MEMORANDUM

Preliminary Plan of Subdivision

PROJECT NAME: Oak Grove

120080320

Attachment B – proposed plan

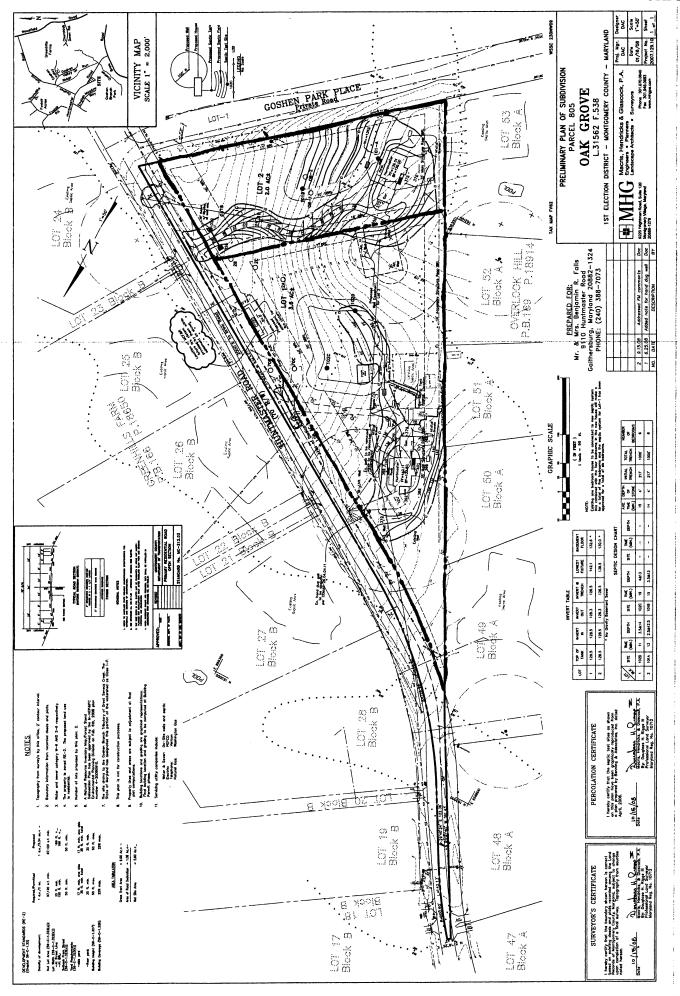
PROJECT DESCRIPTION (Attachment B – proposed plan)

The applicant proposes to subdivide the Property and record 2 lots to accommodate 2 one-family detached dwelling units. Proposed lot 1 is 3.6 acres and proposed lot 2 is 2.0 acres in size. Both lots are to have access via private driveways from Huntmaster Road. The lots are to be served by private wells and private standard septic systems. The existing one-story brick home is to remain as an accessory structure and the masonry block structure is proposed to be incorporated into a newly constructed dwelling unit.

- 1) Approval under this preliminary plan is limited to 2 lots for 2 one-family detached residential dwelling units.
- 2) The applicant must comply with the conditions of approval for the preliminary forest conservation plan. The applicant must satisfy all conditions prior to recording of plat(s) or Montgomery County Department of Permitting Services (MCDPS) issuance of sediment and erosion control permits, as applicable.

- The applicant must dedicate right-of-way for Huntmaster Road along the property frontage to provide for 70 feet of right-of-way from the opposite right-of-way line.

- 7) The applicant must satisfy provisions for access and improvements as required by MCDOT prior to recordation of plat(s).
- 8) Record plat must reflect an easement, as shown on the preliminary plan, to accommodate a potential cistern for fire department water supply.
